# Access Compliance Report

## Public Rights-of-Way

### (Curb Ramps)

Intersection ID: 16271	Main Street: ORMAND_CT	Cross Street: SLOAN_ST	Location:	N
ADA ID: 2E63EED8A430	Ramp Type: Directional1	Initial Pass/Fail: Fail	Overall Compliance: No	Severity Score: 1.25

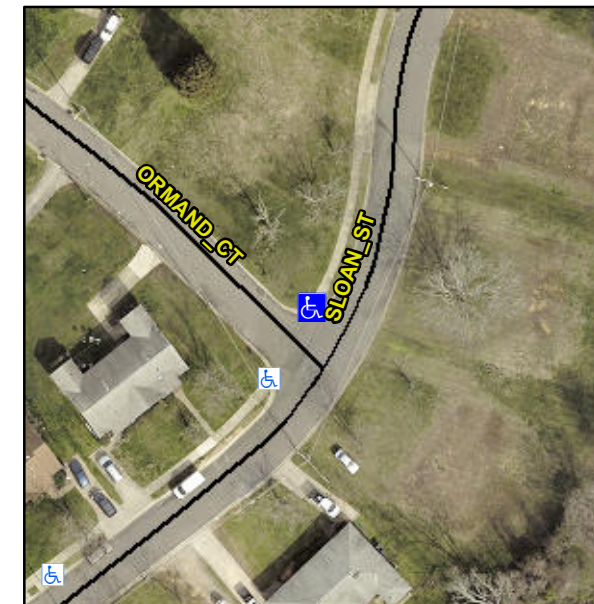
**R304.5.3**

Compliance	Description	Data	Compliance	Description	Data
N/A	Ramp Length (in)	55.0	N/A	Grade Break?	N/A
Yes	Ramp Width (in)	57.0	N/A	Grade Break Slope (%)	0.0
Yes	Ramp Slope (%)	5.9	N/A	Grade Break XSlope (%)	0.0
No	Ramp XSlope (%)	2.3			
N/A	Flare Type LT	N/A	N/A	Flare Type RT	N/A
N/A	Flare Slope LT (%)	N/A	N/A	Flare Slope RT (%)	0.0
N/A	Flare Traversable LT?	N/A	N/A	Flare Traversable RT?	N/A
N/A	Landing Length (in)	0.0	N/A	DWS Provided?	N/A
N/A	Landing Width (in)	0.0	N/A	DWS Contrast?	N/A
N/A	Landing Slope (%)	0.0	N/A	DWS Length (in)	N/A
N/A	Landing X Slope (%)	0.0	N/A	DWS Full Width?	N/A
N/A	Landing Curb? (Y/N)	N/A	N/A	DWS Offset LT (in)	N/A
N/A	Shared Landing?	N/A	N/A	DWS Offset RT (in)	N/A
N/A	Gutter Ponding?	0.0	N/A	Gutter Slope (%)	N/A
N/A	Gutter Lip Ht (in)	0.0	N/A	Gutter X Slope (%)	N/A
N/A	Painted X Walk1?	No		Road Slope (%)	8.8
	X Walk 1 Direction	To SW		Road X Slope (%)	2.2
	X Walk 1 Width (in)	N/A		Clear Space?	N/A

**Remove & Replace Entire Ramp.**
